Value Engineering Study

***EAST NICHOLASVILLE BYPASS
JESSAMINE COUNTY, KENTUCKY***

ITEM NUMBER 7-87.01

Study Date: July 19 - 23, 2010
Draft Report Date: July 30, 2010

VALUE ENGINEERING RECOMMENDATION # VE-18b

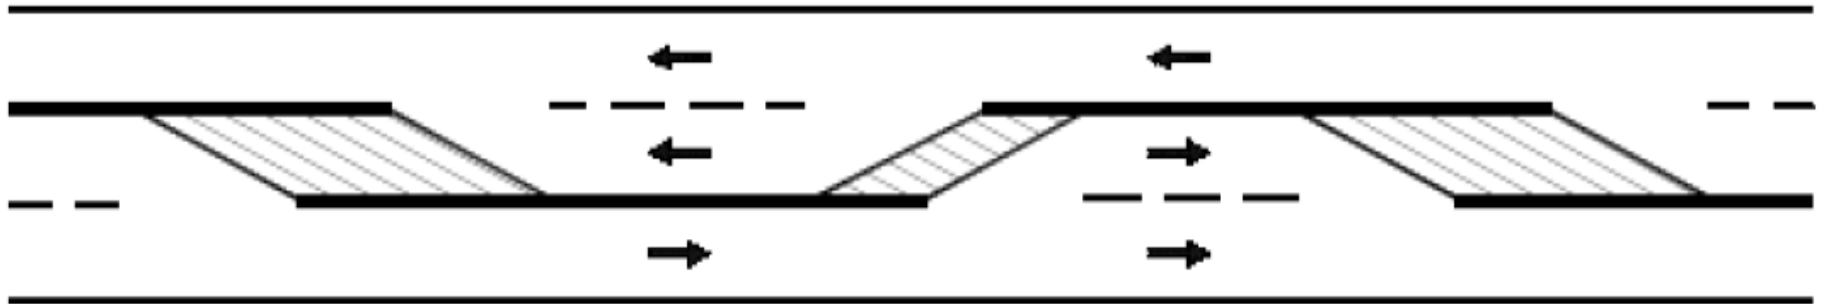
SUMMARY OF COST ANALYSIS			
	First Cost	O & M Costs (Present Worth)	Total LC Cost (Present Worth)
ORIGINAL DESIGN	\$16,737,000	\$0	\$16,737,000
RECOMMENDED DESIGN	\$4,875,000	\$0	\$4,875,000
ESTIMATED SAVINGS OR (COST)	\$11,862,000	\$0	\$11,862,000

VALUE ENGINEERING RECOMMENDATION # VE-19a

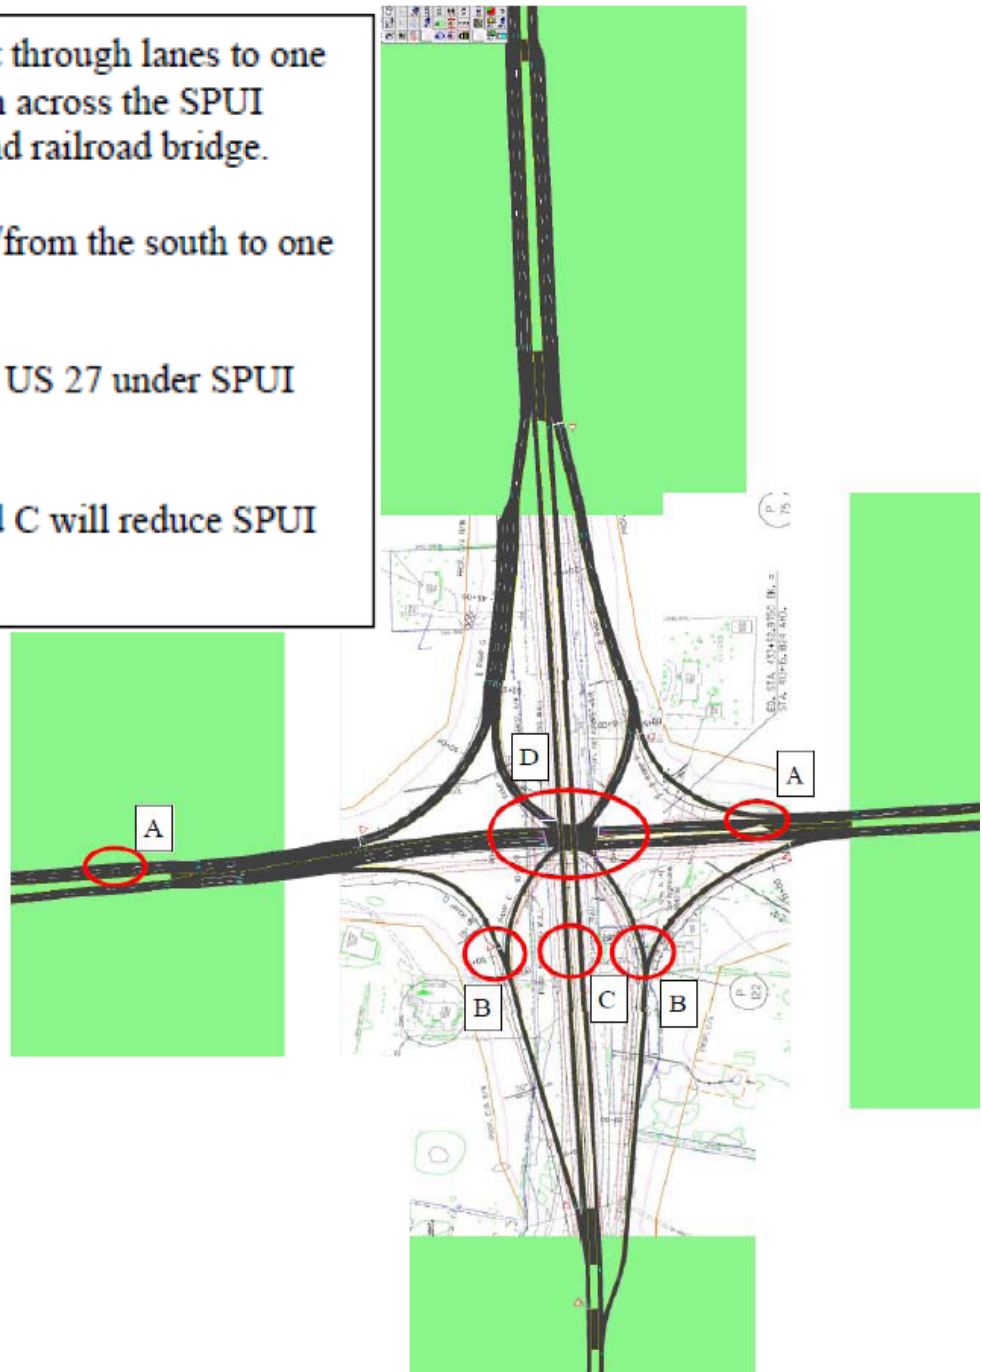
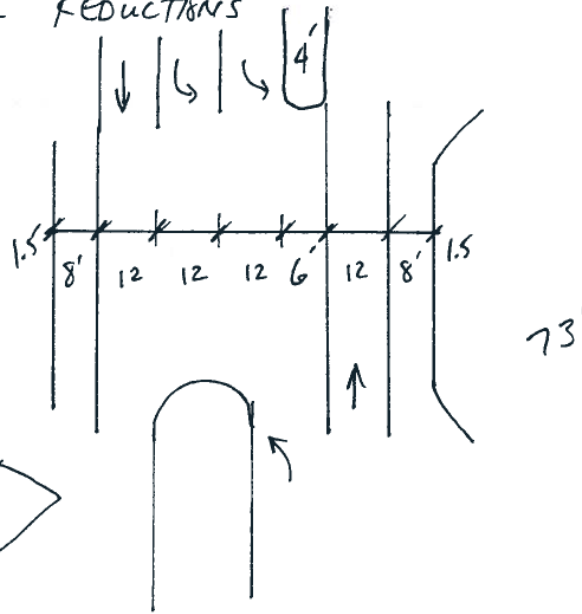
A - Reduce east/west through lanes to one lane in each direction across the SPUI Bridge and westbound railroad bridge.

VALUE ENGINEERING RECOMMENDATION # VE-19c

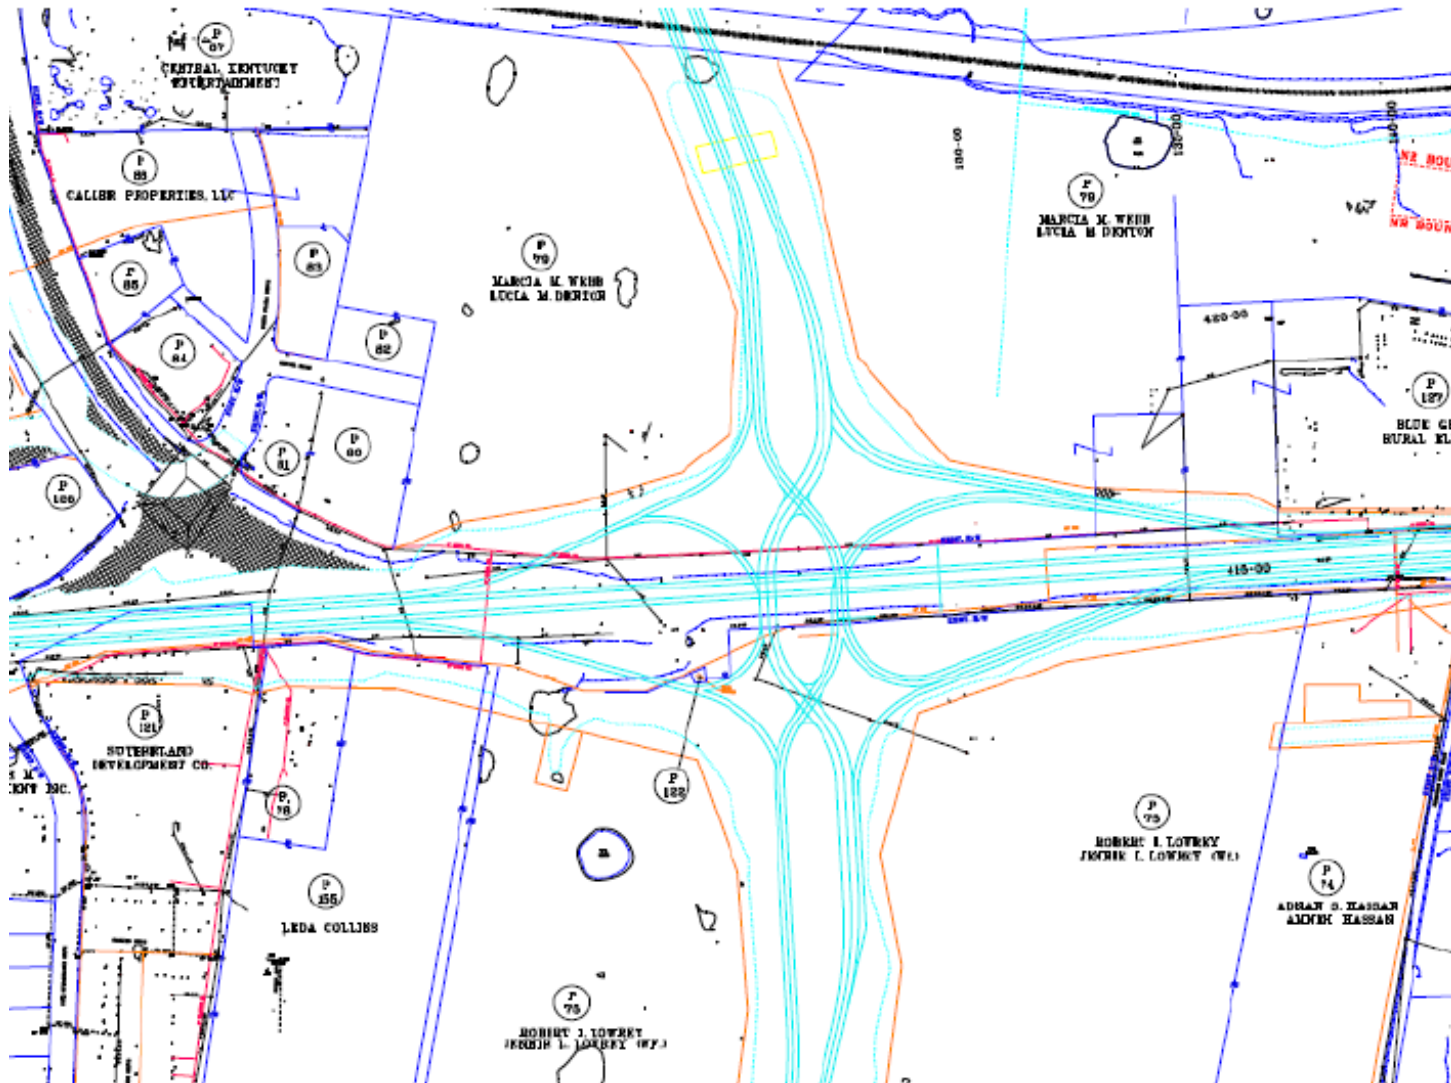
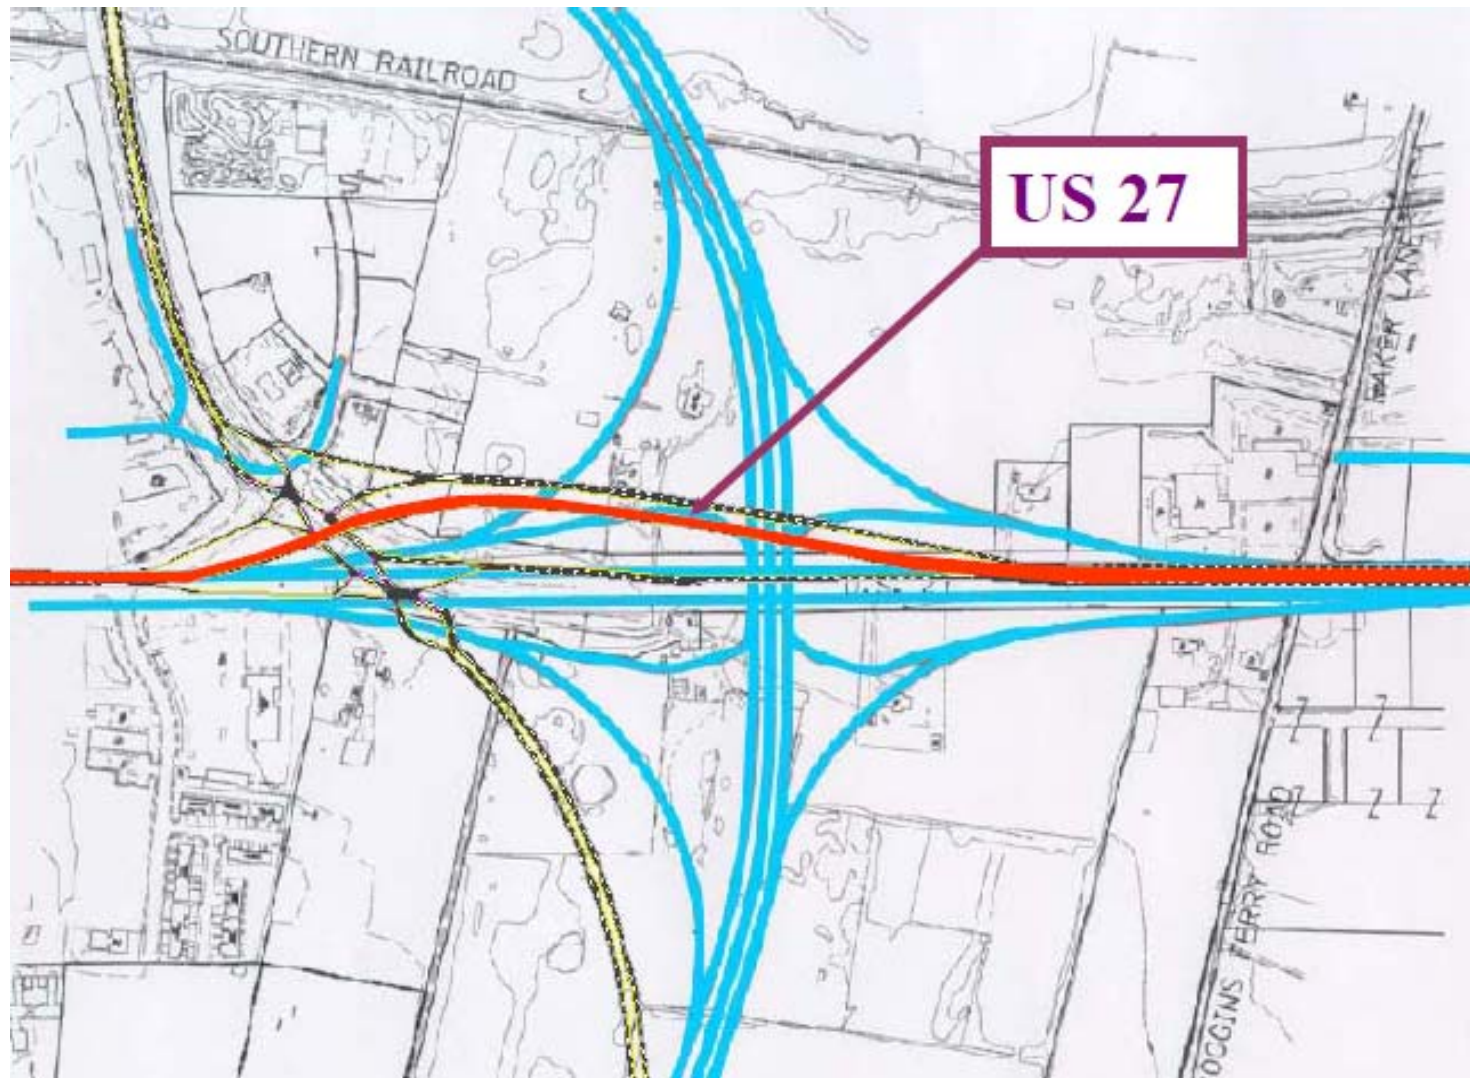
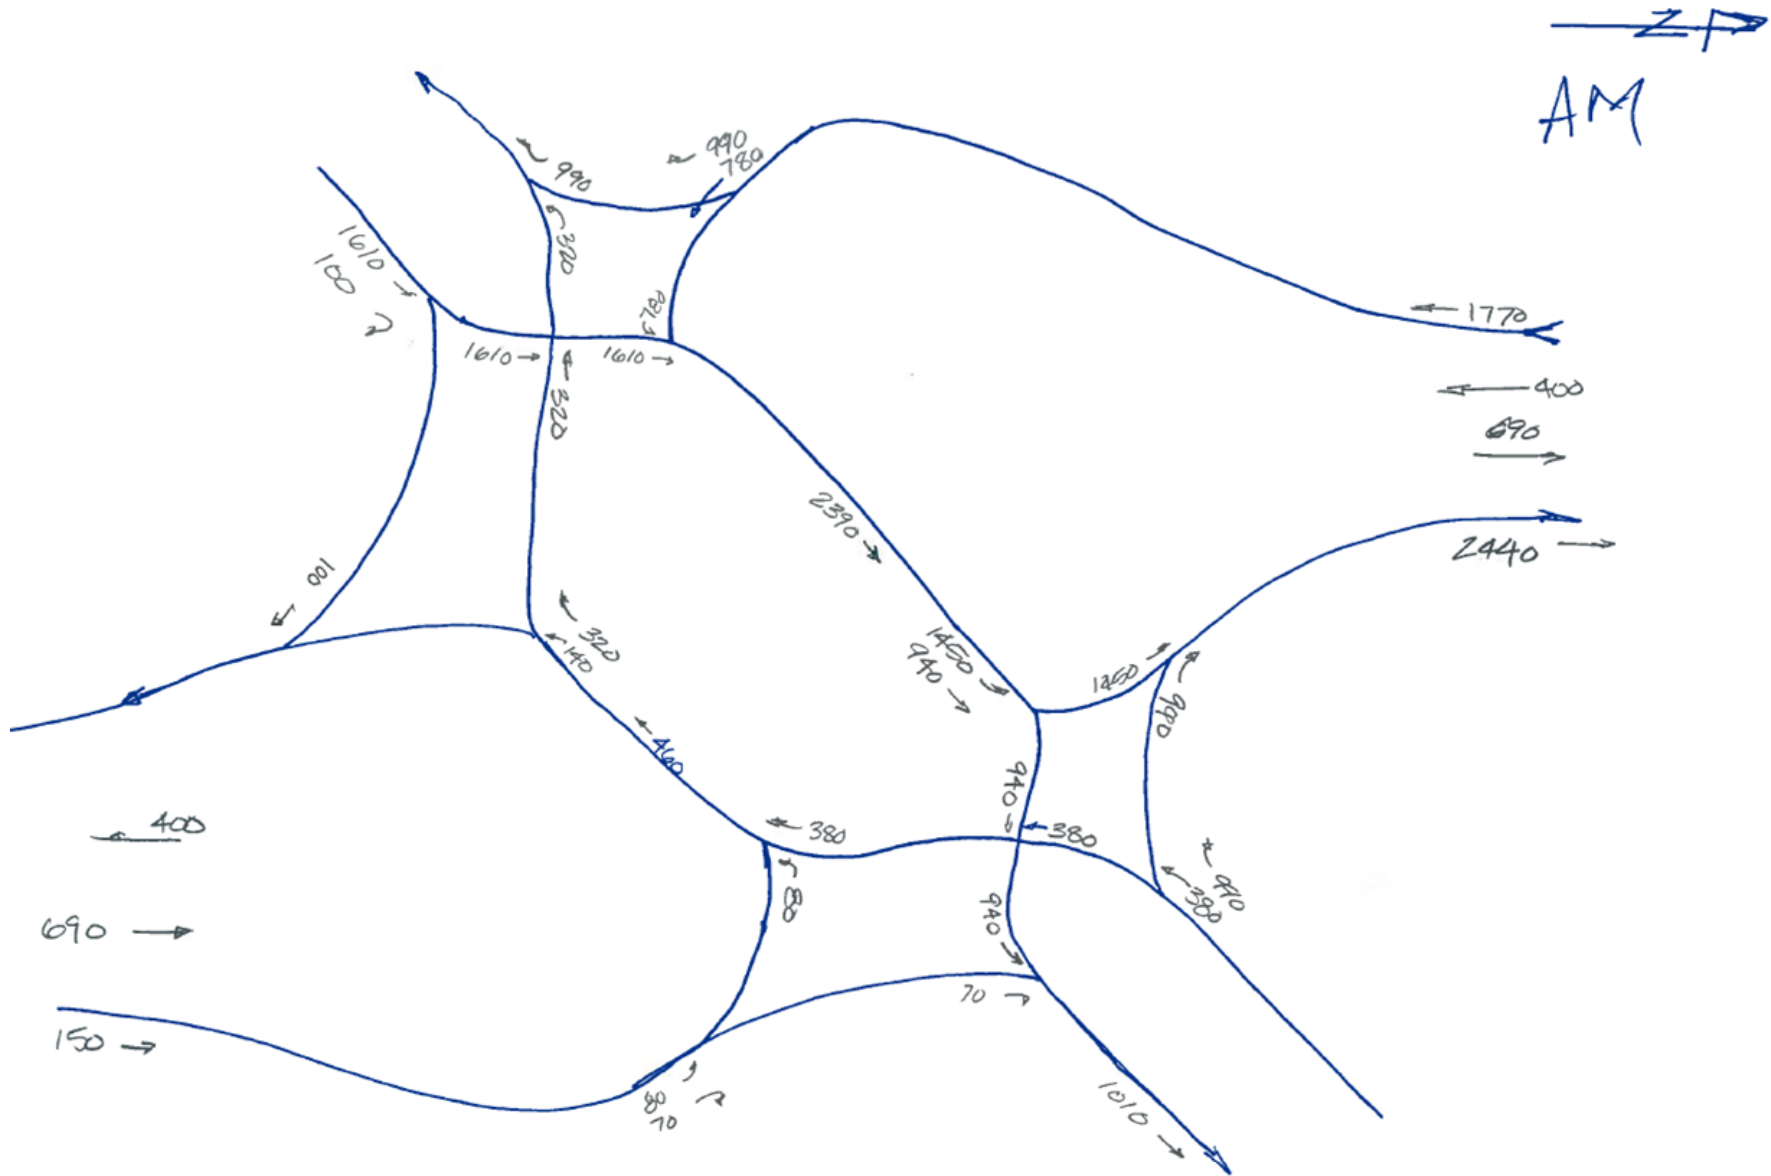
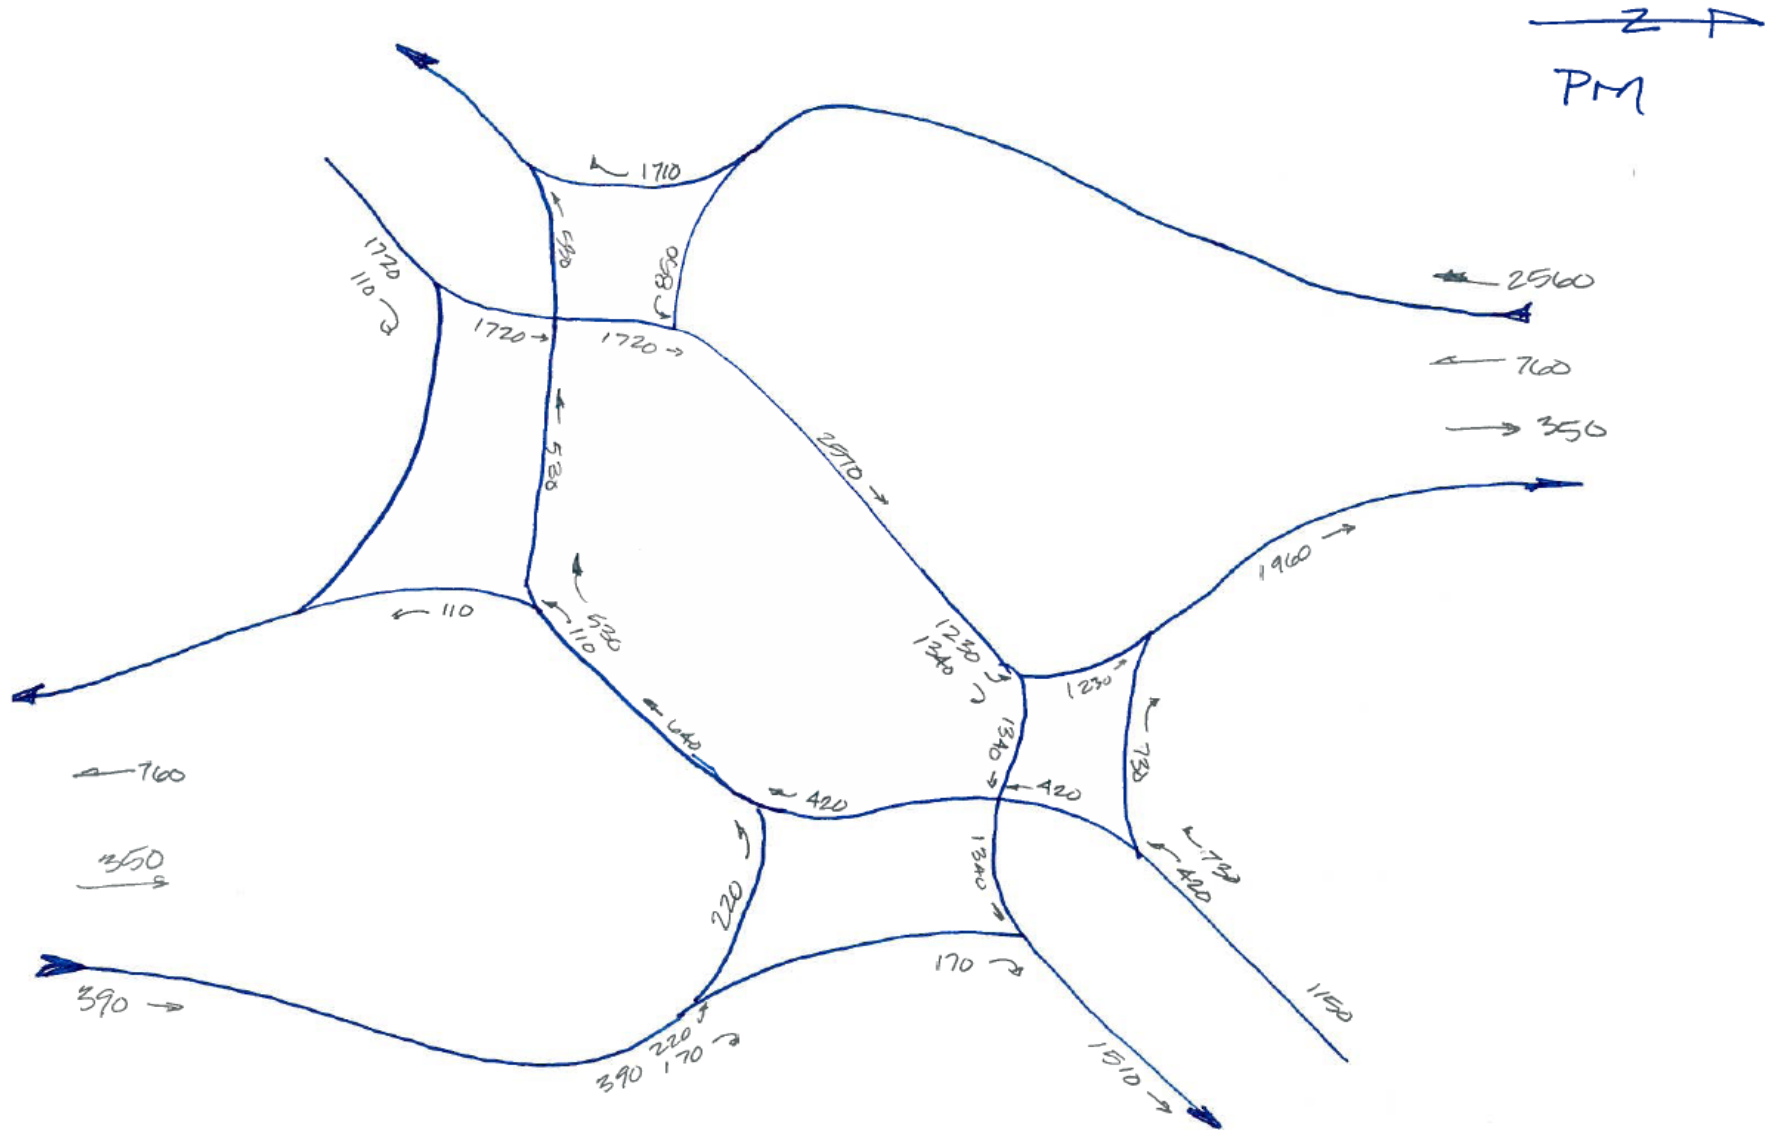
Diverging Diamond Interchange (DDI) located in the proposed SPUI alignment

Diverging Diamond Interchange (DDI) located in the existing interchange alignment
